REQUEST FOR ADDITIONAL INFORMATION NEEDED TO COMPLETE  
THE TECHNICAL REVIEW OF TSTF-424, REVISION 0,  
“RISK-INFORMED HPSI AOT/CT EXTENSION”

**Figure 1  
Illustration of RICT Calculation for Planned Maintenance Activity**

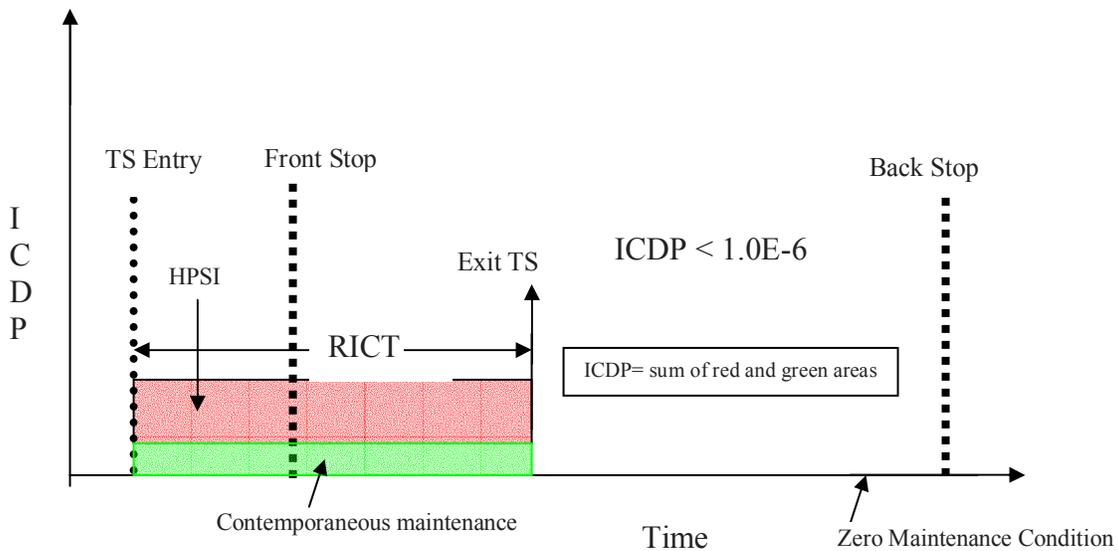
1. The staff requested clarification of the proposed implementation approach with respect to guidance provided in Maintenance Rule (a)(4) and RGs 1.174 and 1.177 (Question 2 of “acceptance review” comments). The industry’s response did not fully clarify all of the staff’s questions. Please answer the following questions, including examples when judged to be helpful.
  - (a) Briefly describe the process, including criteria, that will be used to determine the extended (or “flexible”) AOT/CT (i.e., the amount by which the front stop AOT/CT will be extended) for a given plant configuration. Example(s) could be used to illustrate the process and distinguish among potential cases (e.g., planned maintenance vs. emergent condition during the extended AOT/CT).

1. The RMTS guidance document is applicable to all Technical Specifications that include a flexible Allow Outage Time/Completion Time (AOT/CT) (frontstop and backstop). The general process is illustrated in Figure 1.

Figure 4-1  
CCF Assessment Process

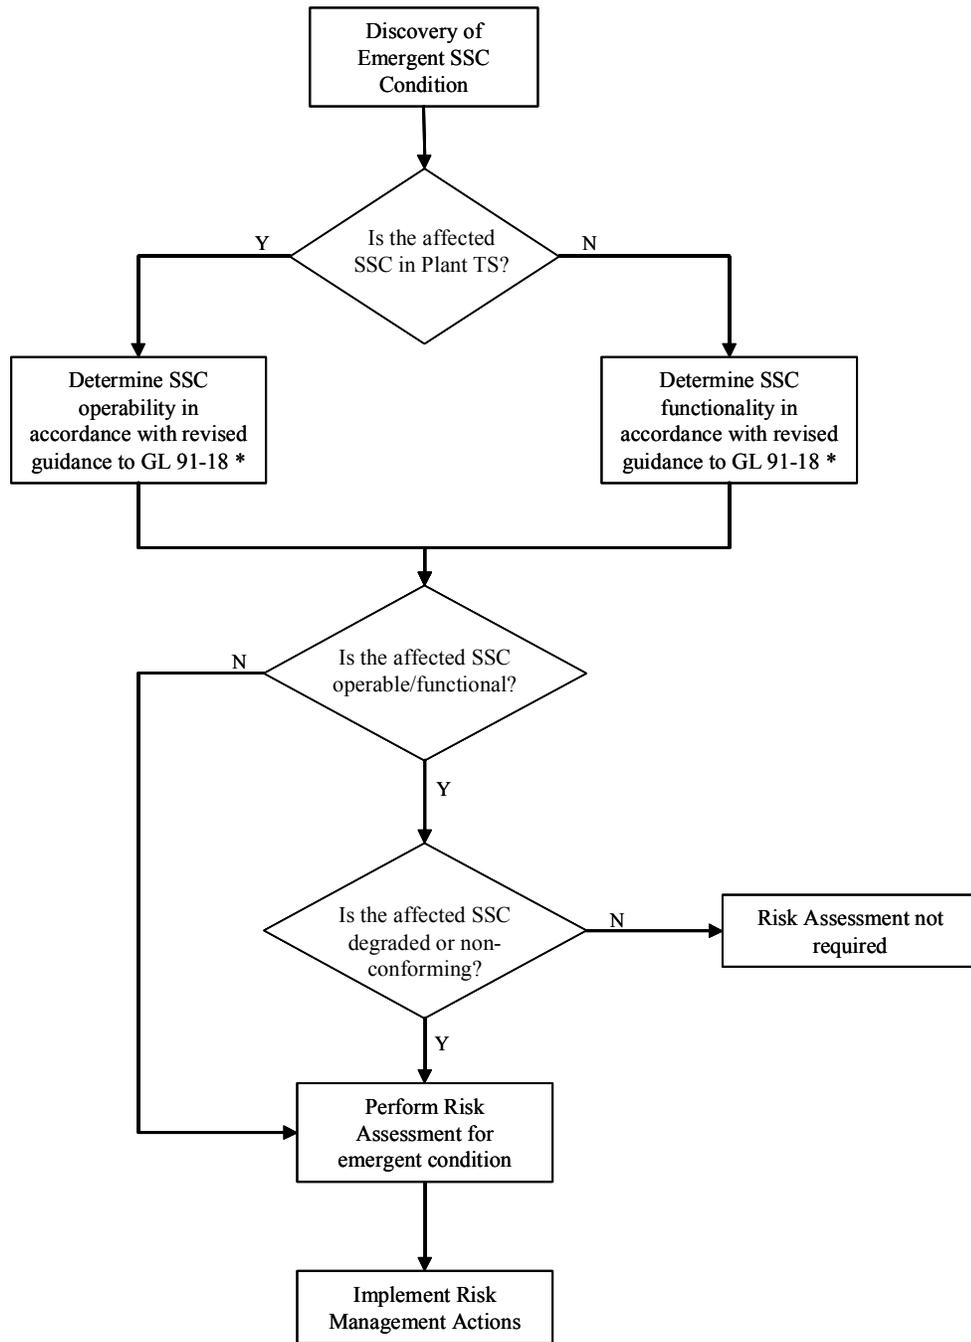
- < **The second element is the “*prompt consideration and resolution of common cause issues (if any).*” Will there be generic and/or plant-specific guidance on how to look for potential common-cause issues and on strategies and actions to resolve any such issues? The common-cause issue needs to be discussed in the revised topical report.**

For the purpose of TS entry, component operability will be assessed by the operator in accordance with GL 91-18. Risk assessments will reflect the emergent nature of the failure and the state of knowledge with regard to redundant components. The risk assessment will be performed in accordance with the guidance in the RMTS Section 3.5.2.3. An overview of this process is presented in Figure 4-1.
